**RE: UDC approval \*\*Response from 2/15/23 UDC comments\*\*:**  
Cousins Subs Remodel – Madison  
3715 E Washington Ave  
Madison, WI  
PATERA, Project Number **22-520**

This submittal is in response to comments made at the previous UDC meeting held on 2/15/2023.

**Photo #1 of completed remodel of Brown Deer, WI location.**

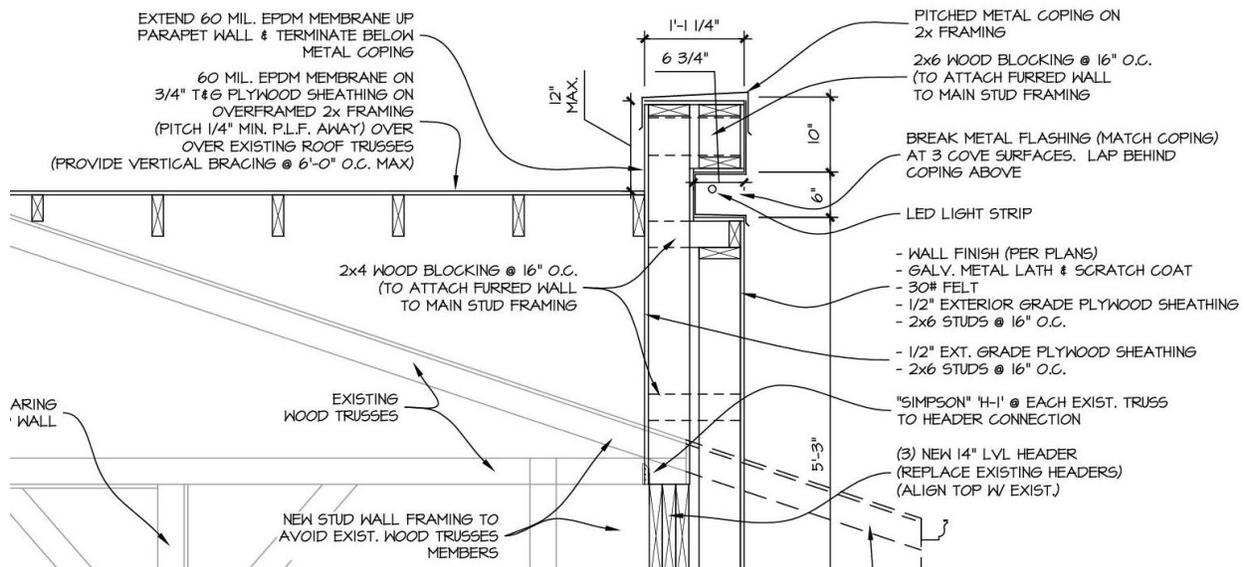
#2: The committee questioned how much of the existing roof would be visible behind the new "wood feature" parapet wall. A second rendering has been submitted showing the other side of the building, in a dusk scene. The roof will be visible and will also have new dimensional asphalt shingles installed. In addition, we have also submitted actual photographs from other completed buildings, of the same prototype building. These were taken at eye level and will be very close representations to this Washington Ave. location. See photos #1 - #3.
